# Planning Commission Agenda Item

Date: December 13,  
2023

**SUBJECT: ZN-14-2023 LAKE MEAD & ENGLESTAD MICROBUSINESS (Public Hearing).** Applicant: Clark County Real Property Management. Request: A Property Reclassification of 4.92 acres from C-1 (Neighborhood Commercial District) to MUD-N (Mixed-Use Neighborhood District). Location: 300 feet West of the Intersection of Lake Mead Boulevard and Englestad Street. (APN 139-22-201-005). Ward 2. (For Possible Action)

The Preliminary Development Plan (Sheet A 1-0) provided by the applicant depicts the commercial building on the southerly portion of the parcel along Lake Mead Boulevard while the four residential buildings are proposed on the remainder of the property.

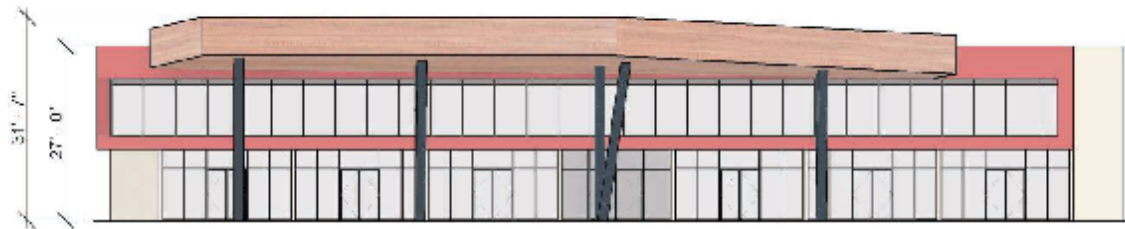
The open space table provided by the architect indicates that 28,625 square feet of private open space is proposed, however, this quantity includes the Civic Plaza and other "community common areas" that are not well defined as dimensions were not provided. The "residential common areas" contain approximately 20,000 square feet as depicted on the Illustrative Site Plan (Sheet A 1-1). Much of this open space area is within the required 20 foot landscaped buffer area adjacent to the single-family residential neighborhood. Normally this buffer area should not qualify as open space area for the residents, however, the applicant is providing recreational and community amenities within this area and does comply with the common open space requirements.

Refuse collection areas and dumpsters should be located away from all street fronts, primary driveway entrances, and pedestrian priority areas and they should be screened from view from rights-of-way, sidewalks, and abutting properties. In order to maintain the maximum amount of parking for the site, the architect has located the trash enclosures strategically at the end of certain parking rows. However, it appears that the areas around the enclosures within the parking lot islands do not have the required landscaping.

**RETAIL BUILDING - ELEVATION A**

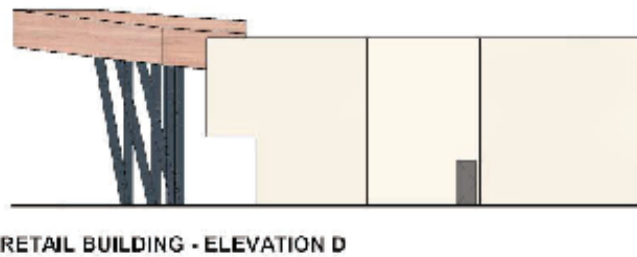
Architecturally, the applicant submitted elevations containing four-sided architecture for the retail building. Elevations A and B appear to be in compliance with the Building Form requirements outlined in the Mixed-Use Design Guidelines. However, Elevations C and D lacks visual interest and have little building articulation or architectural embellishments. All sides of a building shall be coherently designed and treated. A consistent level of detailing and finish is required for all sides of a building. For visual interest, all mixed-use buildings shall incorporate patterns, changes in color, materials, and/or relief such as beltlines, pilasters, pop outs, etc. Appropriately scaled accent features should be used to add visual interest and diversity to building façades. Additionally, the perceived height and bulk of buildings should be relieved by variations in massing and/or articulation of façades to reduce the visual length of long walls. The required changes are relatively minor and will be addressed with the Final Development Plan.
